UNITED STATES ENVIRONMENTAL PROTECTION AGENCY
WASHINGTON, D.C. 20460

July 29, 2008, EPA LANL CCP Inspection Report

1.0 Summary of Purpose

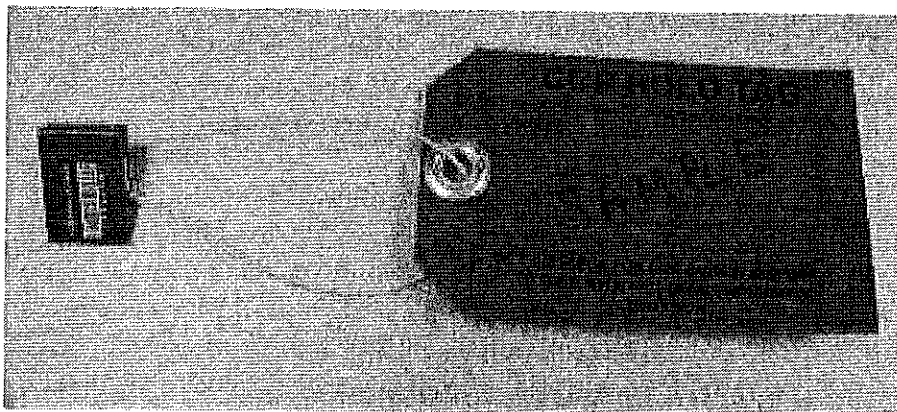
- As a long-term solution, CCP management described and displayed the new tag that will be implemented in the near future. (See picture below.) The tag is thicker plastic than the previously used plastic-coated paper tag and has ultra-violet protection to reduce the risk of failure due to weathering. The tag will be attached by a red metal bracket (with NCR CCP marking) using aircraft grade, twisted steel cable that requires metal cutters to remove. The "CCP HOLD TAG" to be used in the field will have a red (blue in the example in the picture) metal bracket and be appropriately marked, "NCR CCP". CCP plans to use this new tag assembly at all DOE TRU sites where CCP is responsible for characterizing and shipping CH TRU waste for disposal at WIPP. The new tag assembly would ensure that in an event the tag is intentionally removed/ripped off/fallen due to weathering, the red metal bracket with the "NCR CCP" marking will remain attached unless purposefully cut using a wire cutter. This step would prevent recurrence of the shipment and disposal of a previously tagged drum with an open NCR.
